ADDENDUM NO. 1
CONTRACT NO. CP8126-1 – GENERAL, MECHANICAL AND
ELECTRICAL CONSTRUCTION
DATED: SEPTEMBER 10, 2010

**SUFFOLK COUNTY DEPARTMENT OF PUBLIC WORKS
DIVISION OF SANITATION
HAUPPAUGE INDUSTRIAL PARK
S.C.S.D. NO. 18 – INDUSTRIAL SEWER DISTRICT EXPANSION
SUFF 0503**

VV. SHEET H-E6:

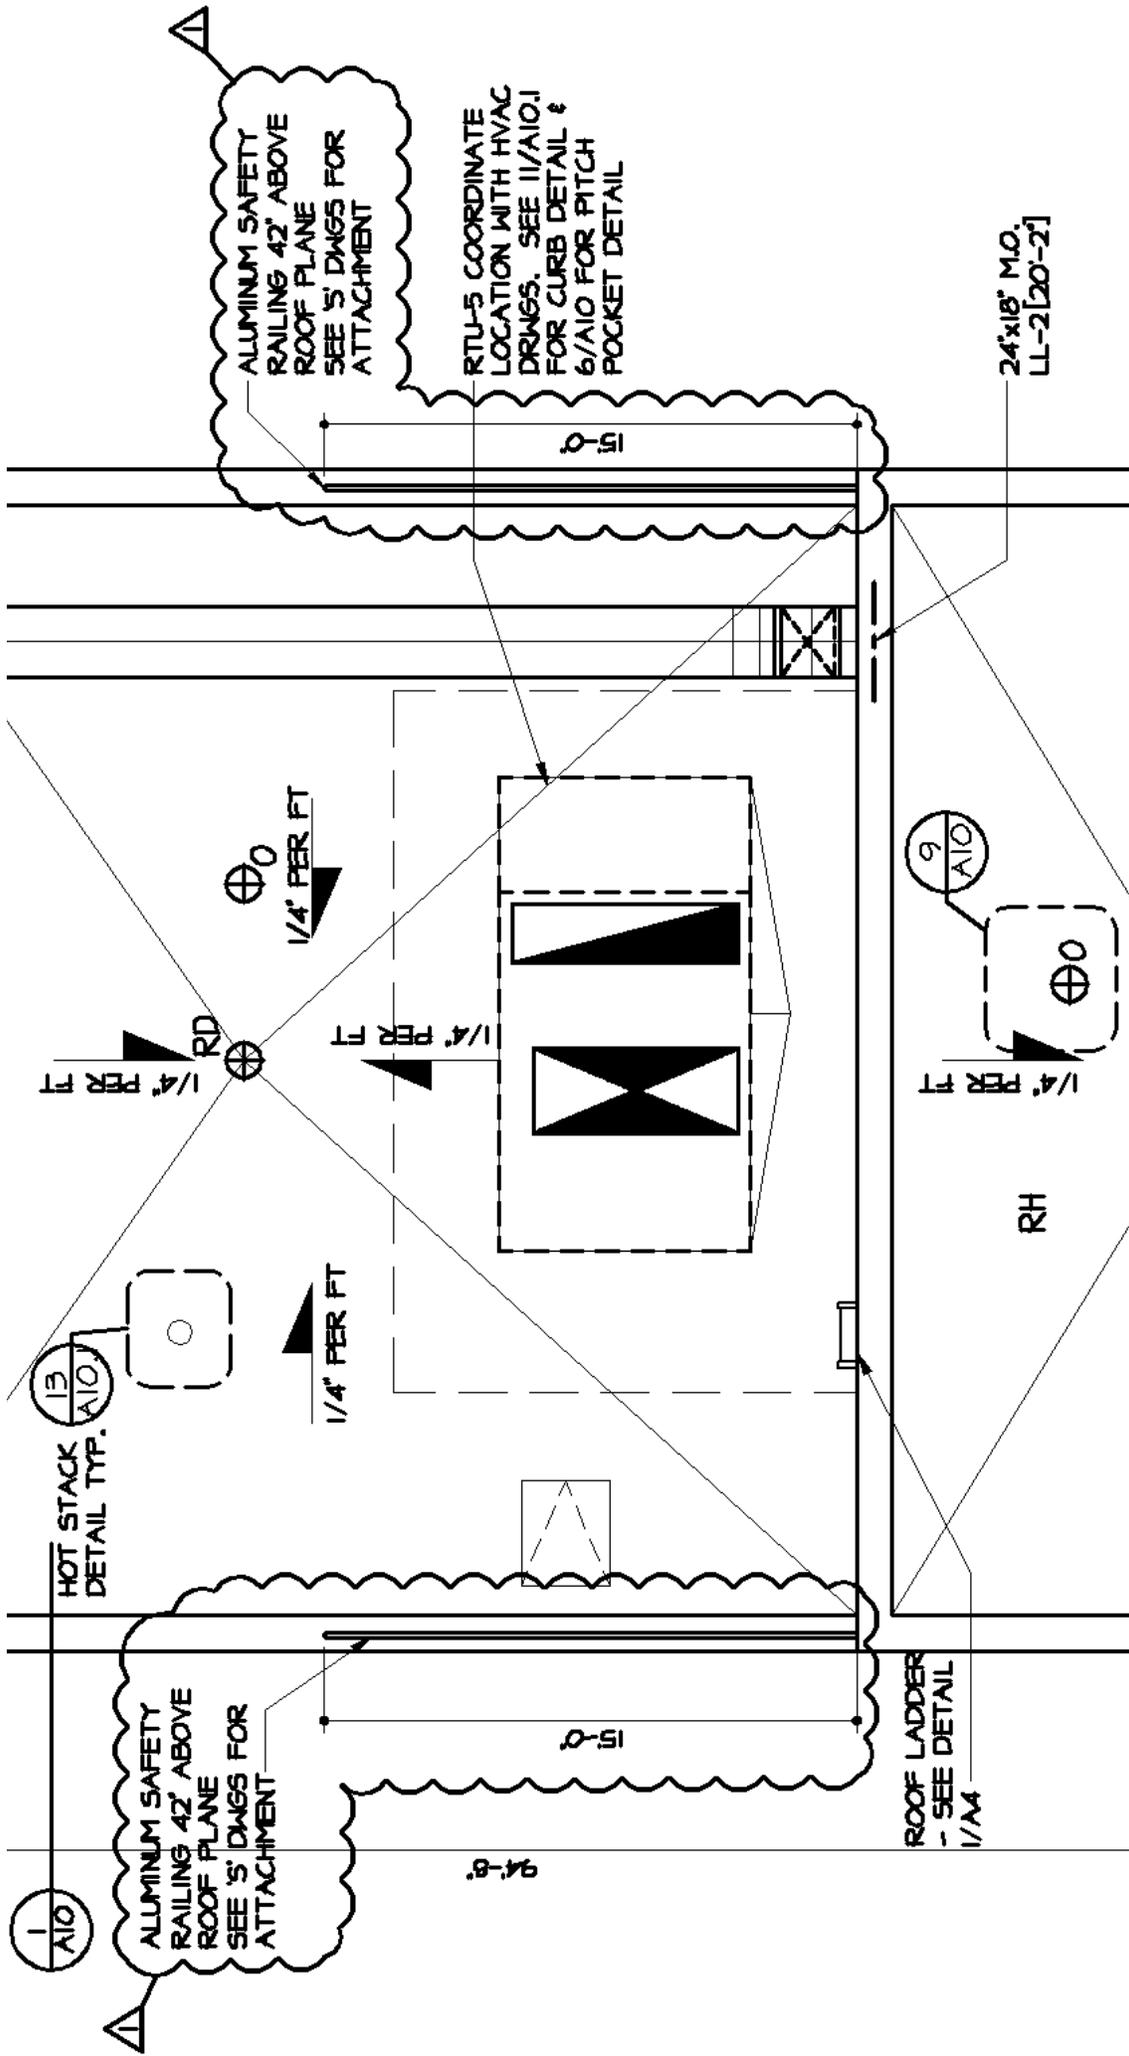
1. Section 1: Shift the location of leader for expansion material callout to the interface between the generator pad and slab below aluminum stairs.
2. Detail 2: Reference detail #5 on sheet H-E7 for each of the section view callouts.

SHEET A7 - SKETCH # 2

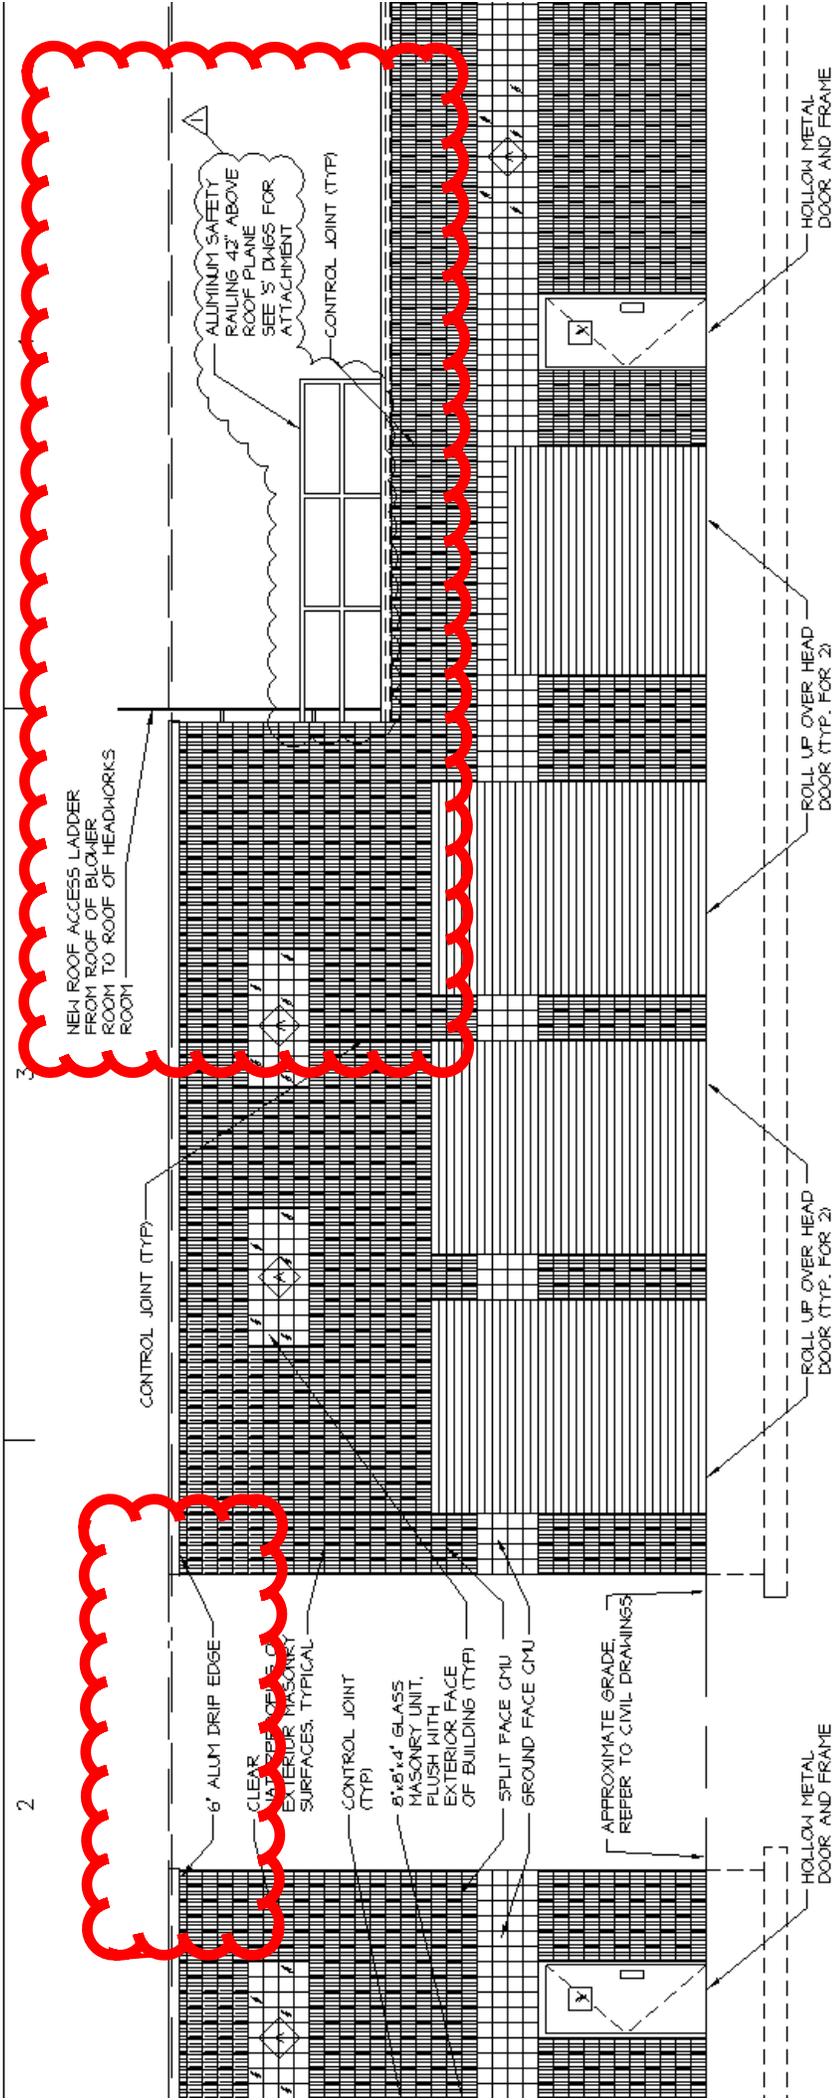
1. Add safety railing and associated callout on the north edge of the roof above the blower room, extending east the same length as the railing previously included on the south edge of the roof above the blower room.
2. Add dimensional callout for required lengths of safety railing along north and south walls of headworks building.
3. Update callout for previously included safety railing along south side of headworks building.
4. Above revisions as shown on Sketch #2 included herein.

SUFF 0503
ADDENDUM #1 - ITEMS F1 - F3
SHEET A8 - SKETCH # 3

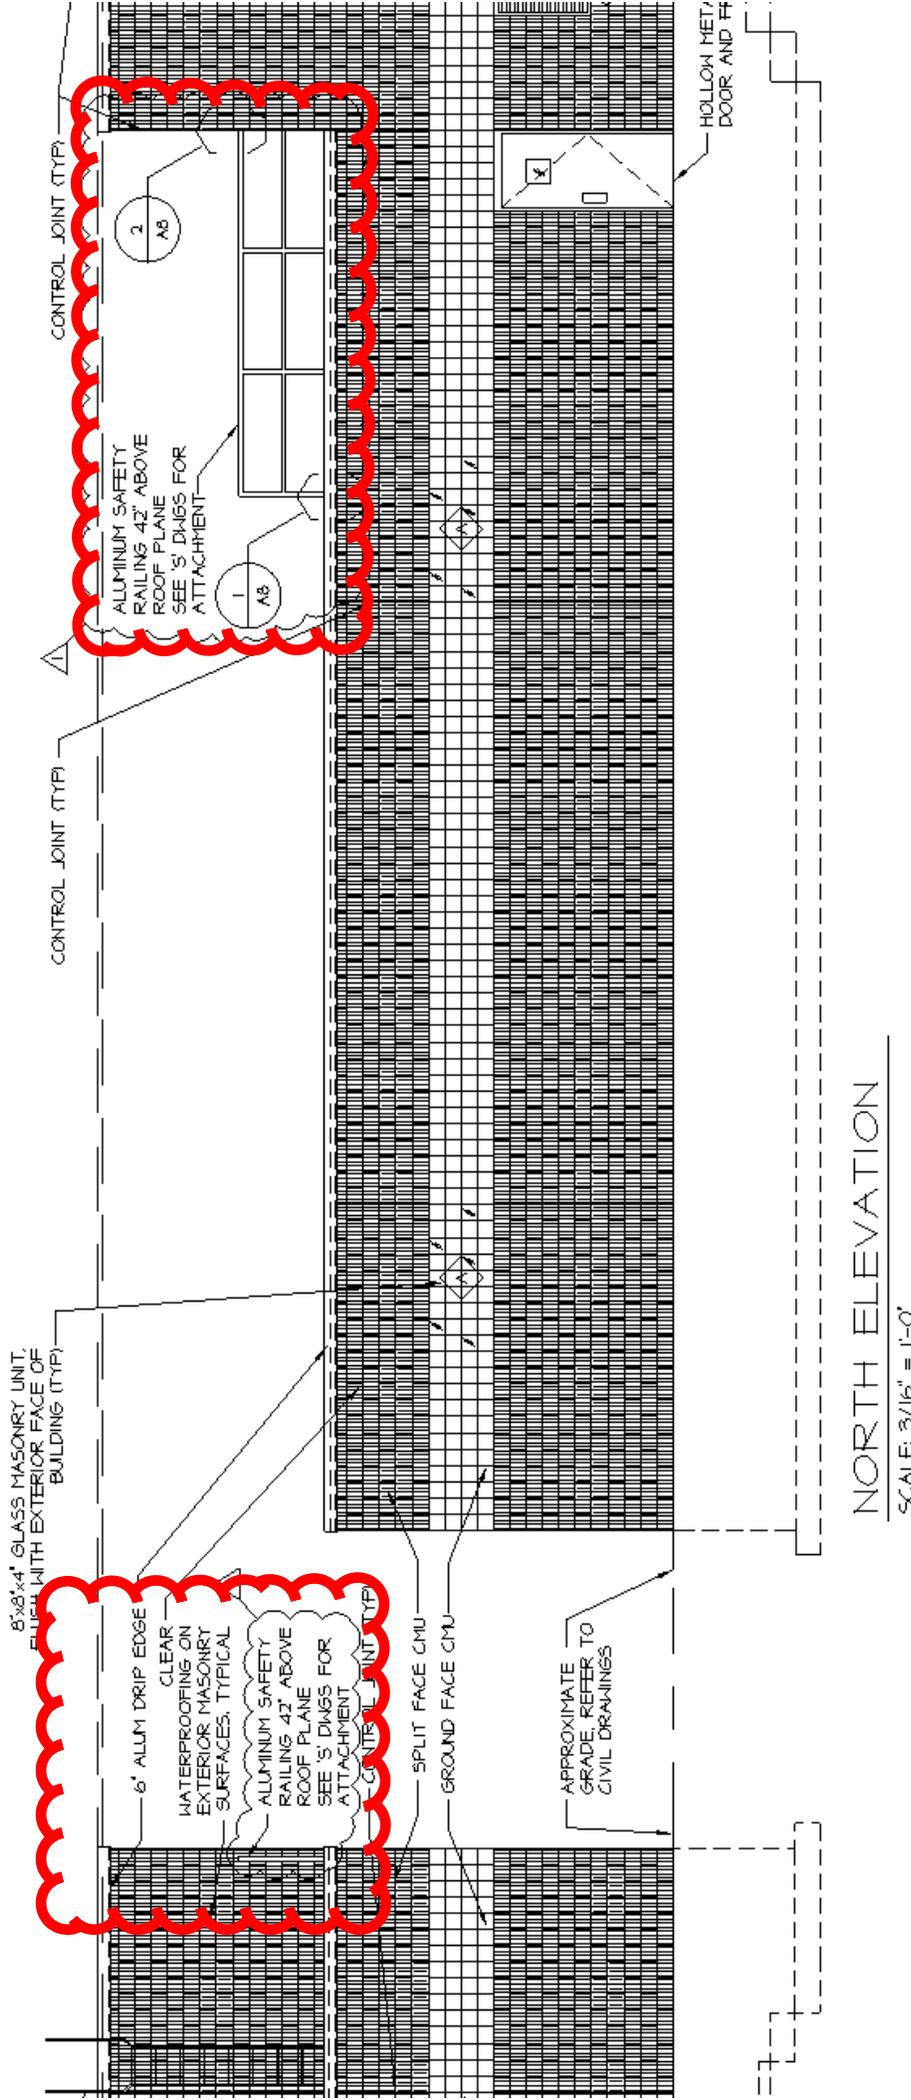
1. SOUTH ELEVATION: Move leader of callout for roof access ladder to correctly identify said ladder.
2. EAST, WEST and SOUTH ELEVATIONS: Move leaders for “6-inch ALUM DRIP EDGE” callouts to correctly identify said edging.
3. EAST, SOUTH AND NORTH ELEVATIONS: Show safety railing above blower room and add associated callouts.
4. Add details illustrating connections of safety railing to roof of blower room and to vertical wall of headworks room.
5. Above revisions as shown on Sketches #3, #4 and #5 included herein.

SUFF 0503
ADDENDUM #1 - ITEM J3
SHEET ESP1 - SKETCH # 6

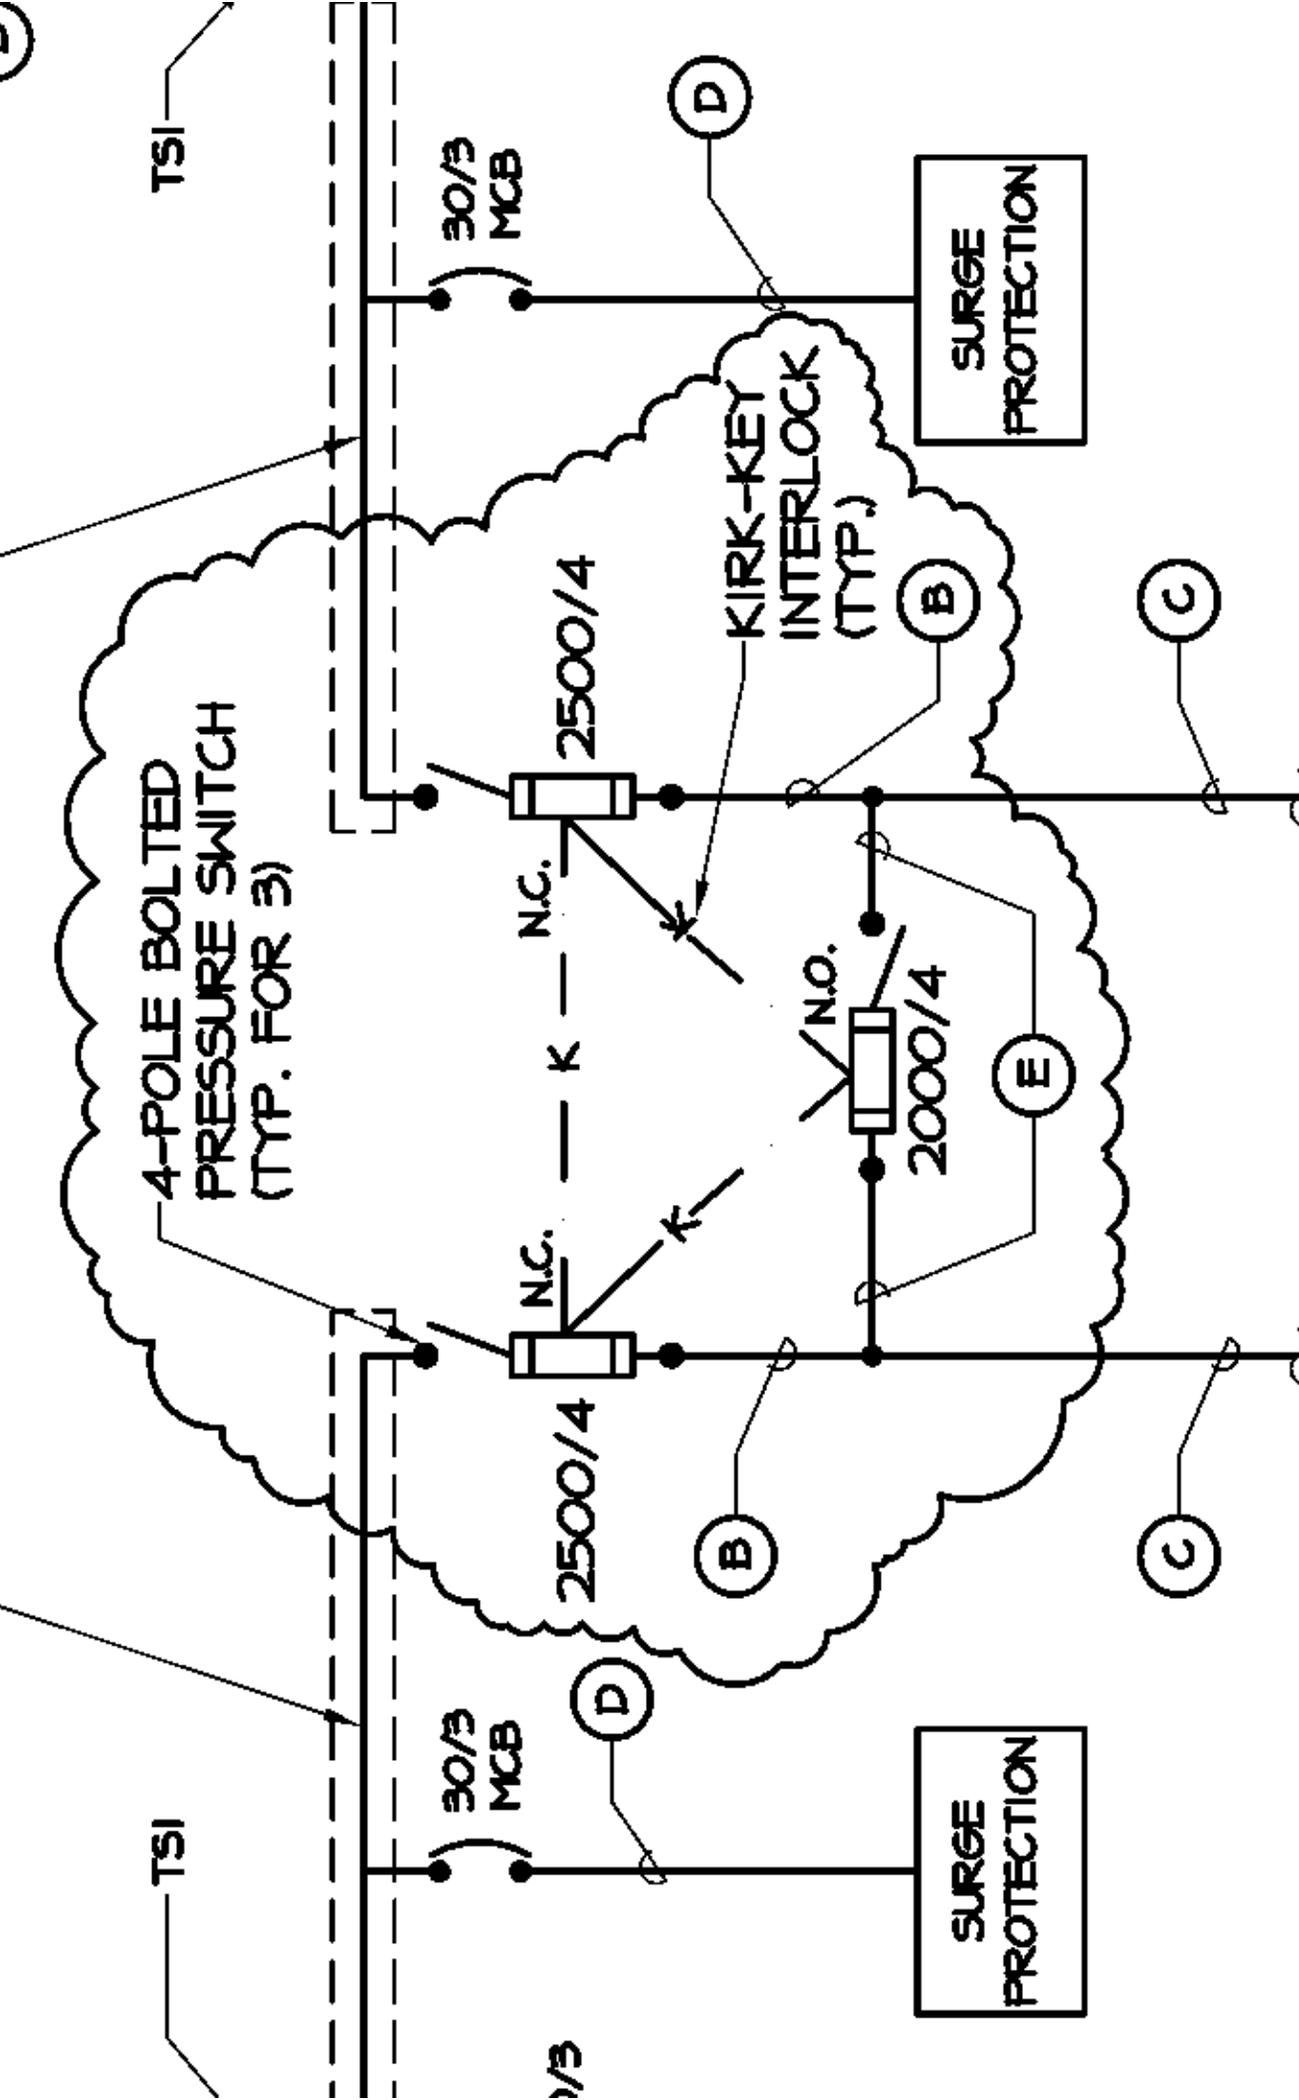
3. Access Road Utility Plan:
 - a. Relocate MATCHLINE to coincide with that of the Electrical Site Plan.
 - b. Add leaders to the callouts for “EXIST 12” DIAM DIP” and “EXIST 6””.
 - c. Remove reference to note 19 from callout that also refers to notes 1, 17 and 18.
 - d. Above revisions as shown on Sketch #6 included herein.

SUFF 0503
ADDENDUM #1 - ITEM M
SHEET SLD3 - SKETCH # 7

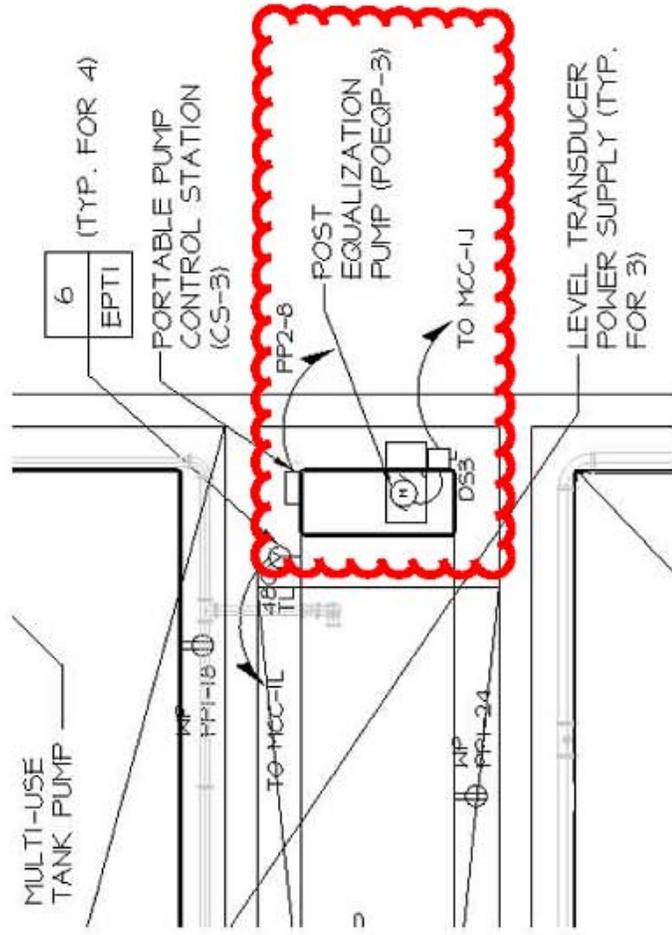
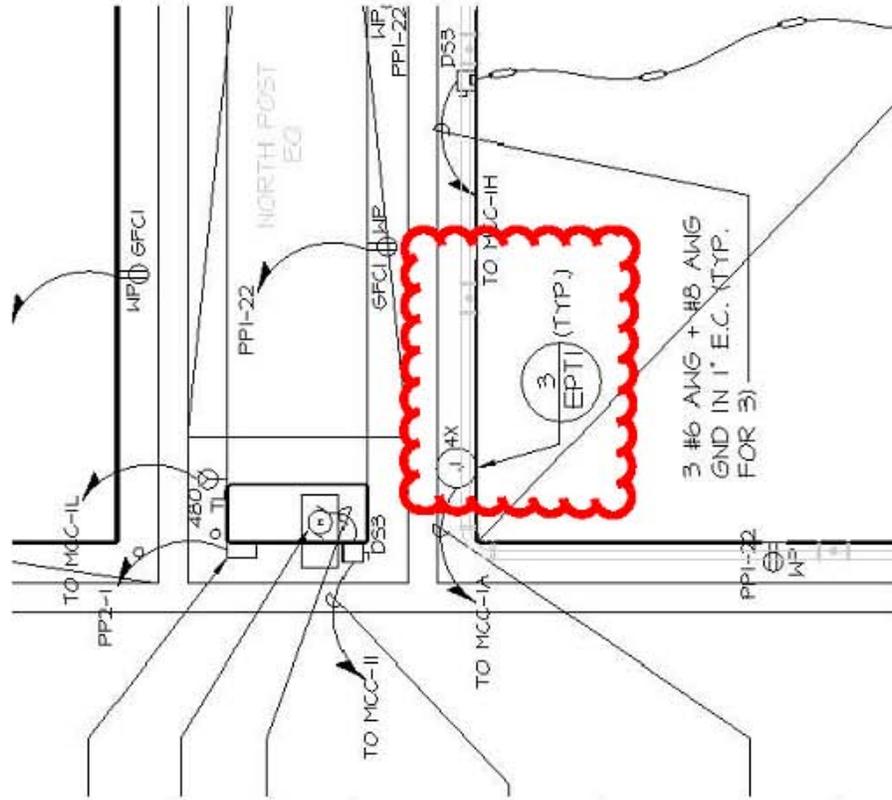
- M. SHEET SLD3:
 1. Modify each of the three (3) circuit breakers of the KIRK-KEY INTERLOCK to be a 4-pole bolted pressure switch, as shown on Sketch #7 included herein.

SHEET EPT1-SKETCH # 8

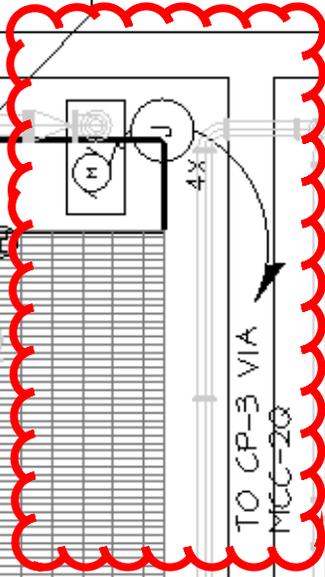
1. Shift location of multi-use tank motor south to show it being within sump along south wall of tank.
2. Modify callout for junction box detail from “1/EPT1” to “3/EPT1” as shown on Sketch #8 included herein.
3. Add POST EQUALIZATION PUMP (POEQP-3) within sump along south wall of SOUTH POST-EQ tank along with associated power wiring as shown on Sketch #8 included herein.
